Levin-Richmond Terminal Corporation

February 18, 1997

Re: United Heckathorn Superfund Site Work Plan - Completion of Dredging in the Lauritzen Channel

PLAN DREDGE DEPTH ———
PLS 1/30/97 DEPTH = = =
LRT EXPECTED DEPTH - - -

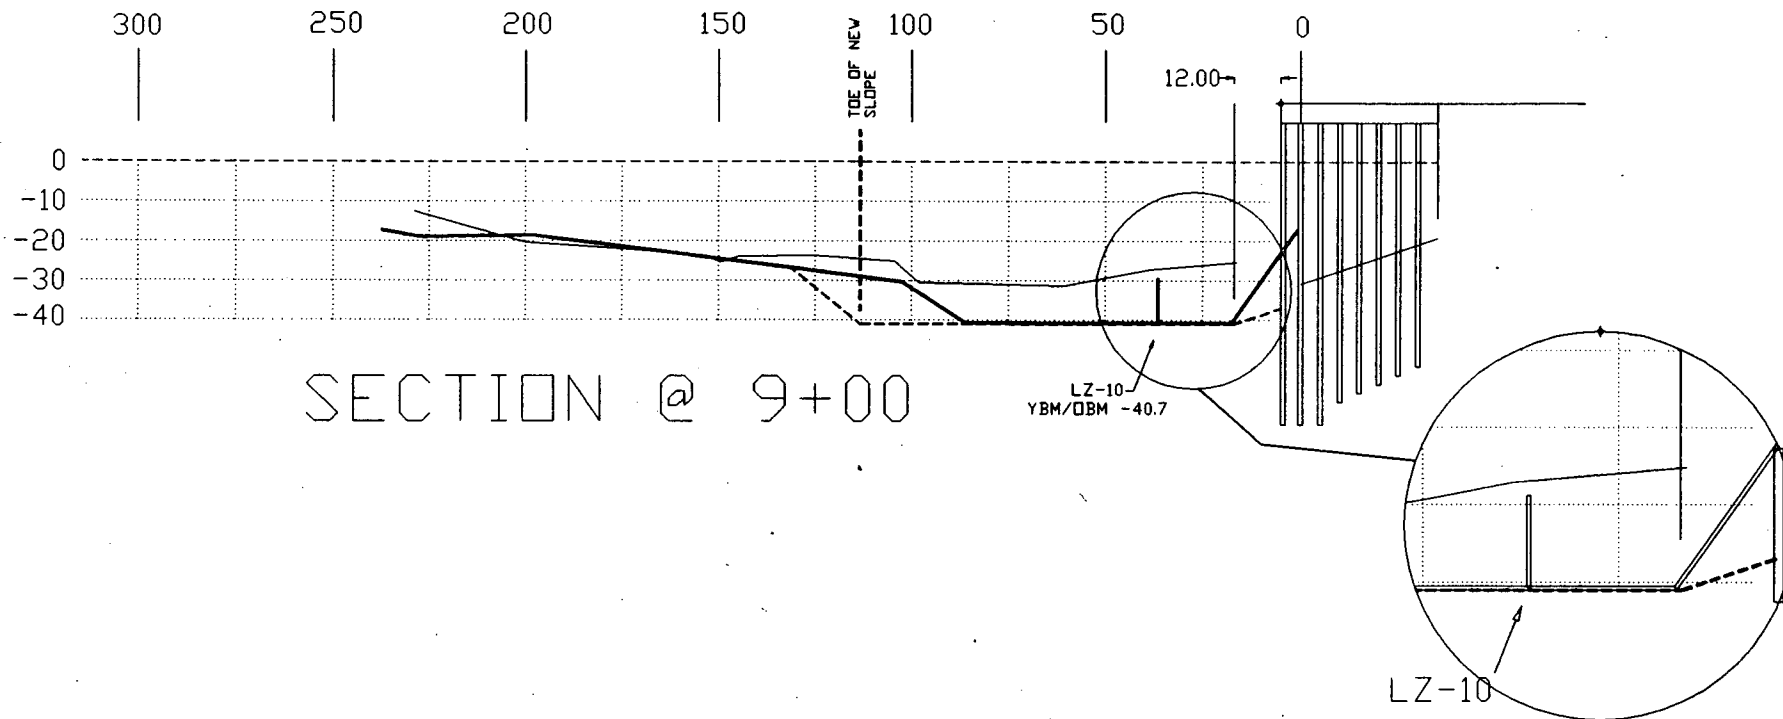
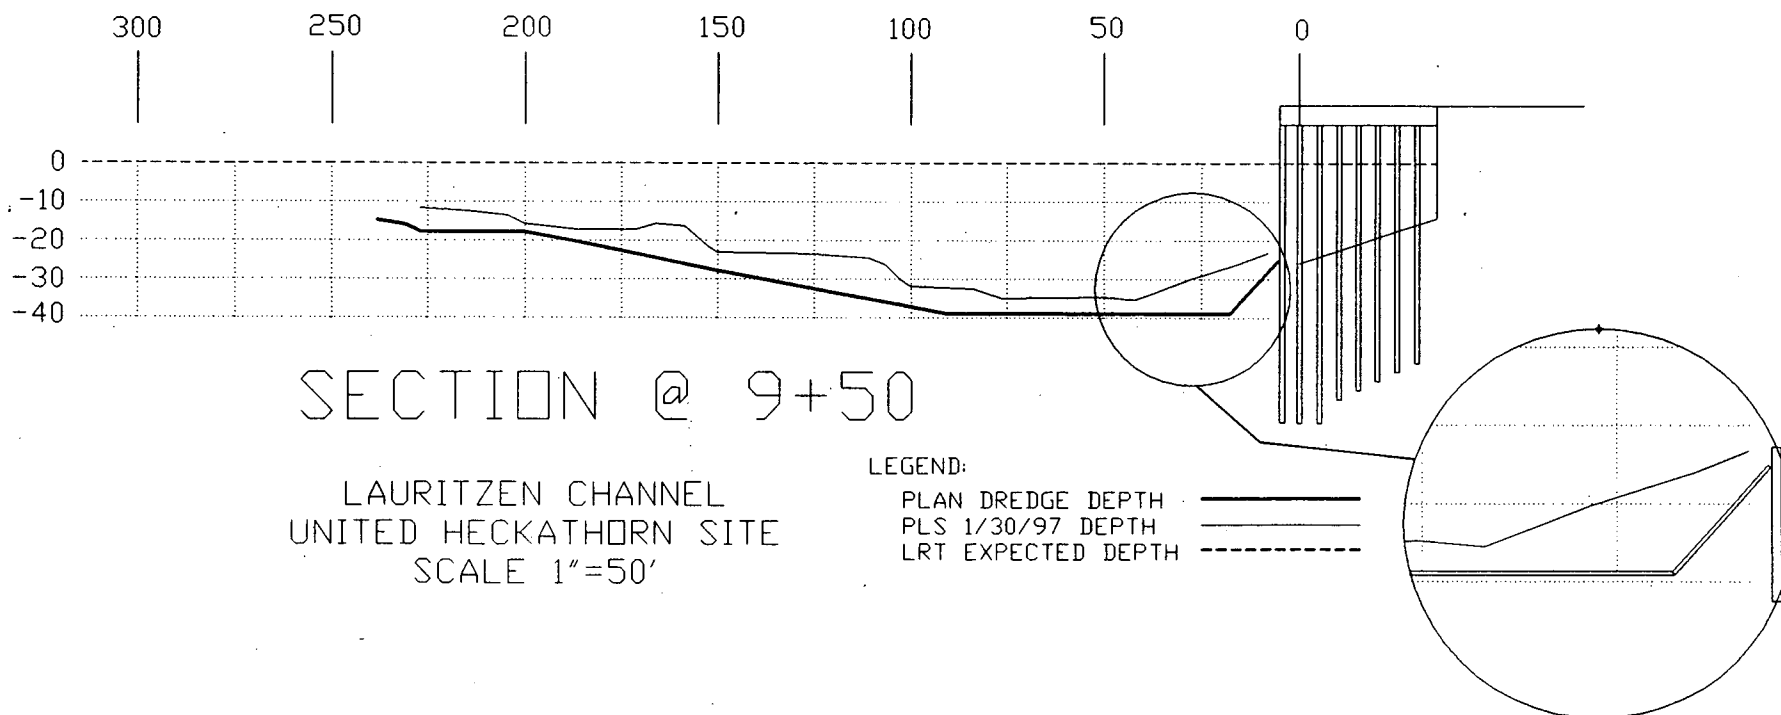
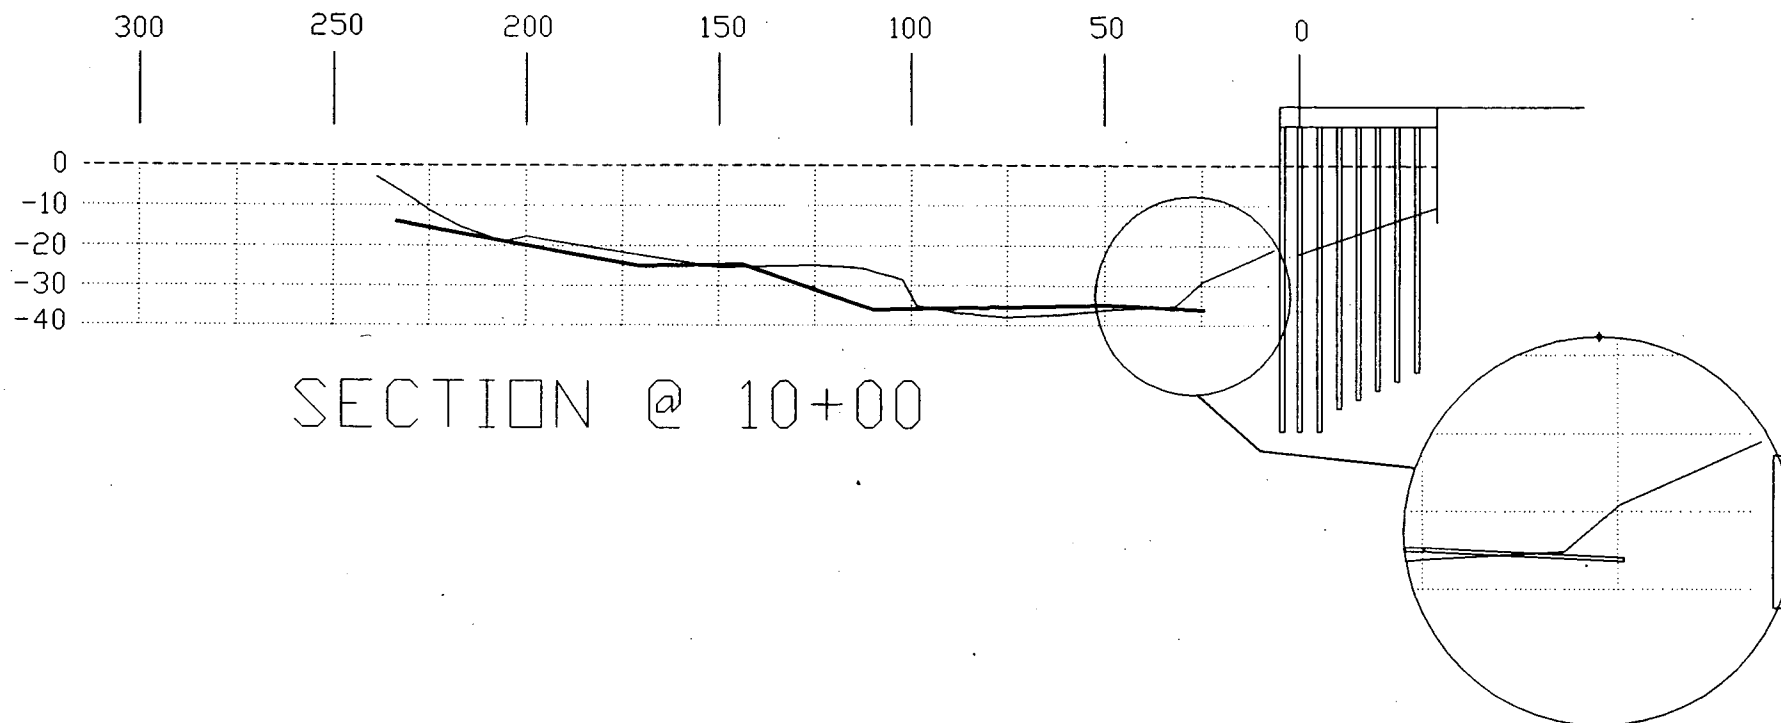
To compare the Work Plan Appendix A and the Channel Cross Sections (Exhibit #3) with the depths indicated on the PLS survey dated January 31, 1997, we have used CAD drawings to superimpose both documents on the attached cross sectional drawings (LRT Attachment #A). We have plotted each 50 ft. interval to get a better understanding of the depth of the remaining material to be removed according to the Work Plan, and have included them for your review and response. Also included are copies of the core samples taken by Battelle indicating the depth of the YBM/OBM interface. We don't have access to the samples used to map the interface, however, the depth appears to be

From these observations it is clear that the Work Plan depths have not been achieved. There are discrepancies from 2 ft. to over 10 ft. of YBM containing contaminated materials that have not been dredged. Note on section 9+00 that the Battelle core sample LZ-10 indicates the YBM/OBM interface at -40.7 ft. and that the plan depth is shown at -41 ft., but the dredged depth, as shown, is approximately 15 ft. shallower. (See the included grid map for Battelle core sample locations and depths, LRT Attachment C.) The depths indicated in the Work Plan should be the guideline to assure that all of the dredgable contaminated material has been removed. As the site owners we want to insure that all of the contamination required to be removed by the Montrose Consent Decree and Work Plan have been removed.

SECTIONS OF 1VERT ON 3HORIZ
WITH
RESULTING ELEVATIONS

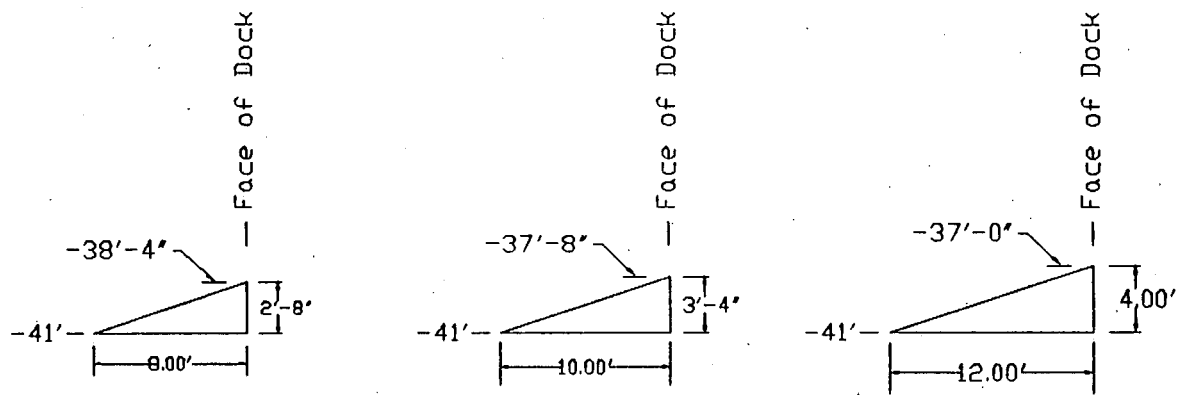
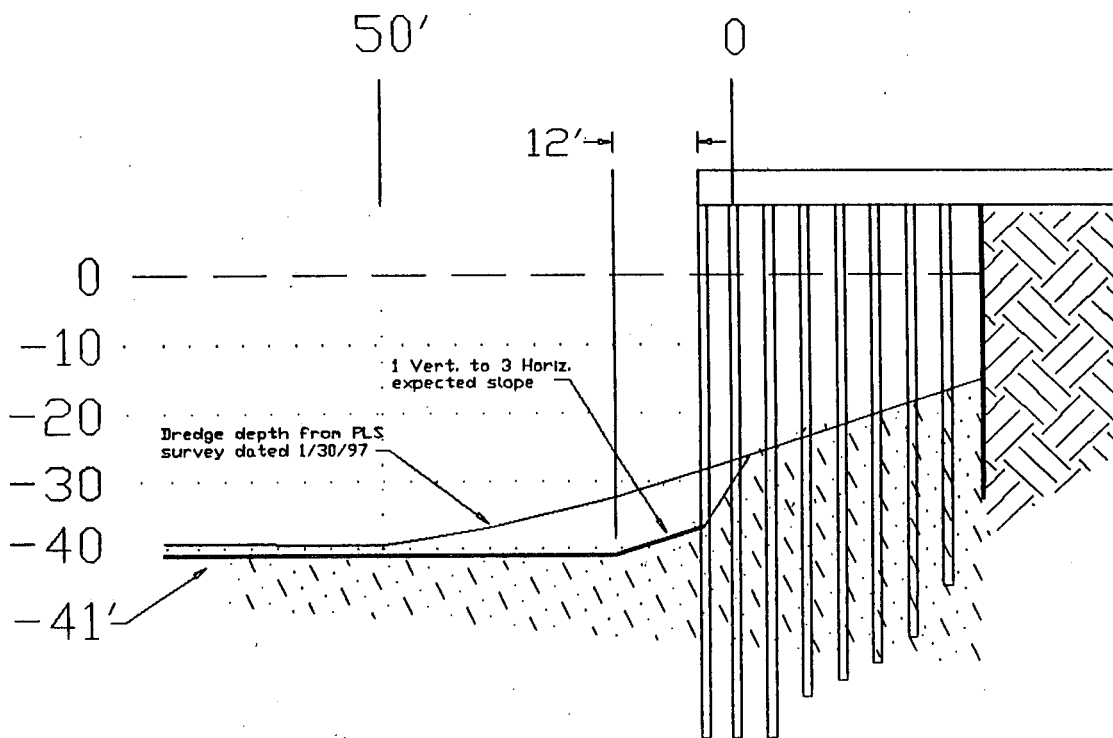
between -40.7 ft. and -42.6 ft.. If the toe of the slope is 10 ft. plus or minus 2 ft. from the face of the dock, the resulting elevations, along with a section at 8+00, are shown in LRT Attachment B.
